**BMW Motorrad
USA
Service Information Bulletin**

****Notice of Recall 14V-065****

Subject: Side-stand switch

Model: C 600 SPORT (K18), C 650 GT (K19), R 1200 R (K27/11), R 1200 GS (K50), F 700 GS (K70/11), F 800 GT (K71/11), F 800 GS (K72/11), F 800 GS ADV (K75).

Illustration: Side-stand switch (F 800 GS as example)

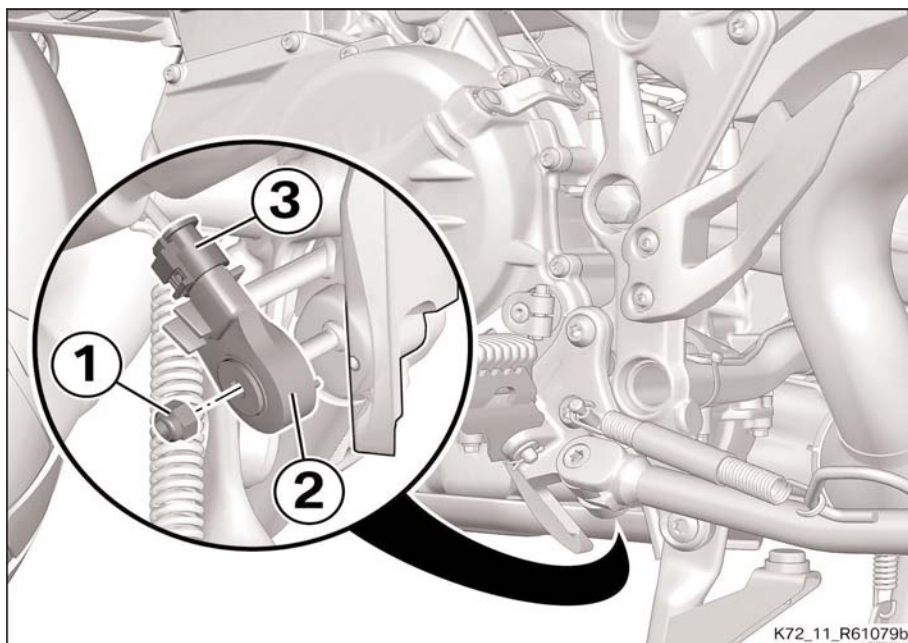
Details: BMW Motorrad has ascertained that due to a production fault, in some instances the side-stand switches are not correctly sealed. In rare cases water penetrating inside the switch can cause the side-stand switch to malfunction. The possibility of this malfunction causing the engine to shut down while riding cannot be excluded.

Aftersales Solution: The side-stand switch has to be replaced as described in work item 61 31 302 on the current RSD (Repair and Service Data BMW Motorrad) DVD.
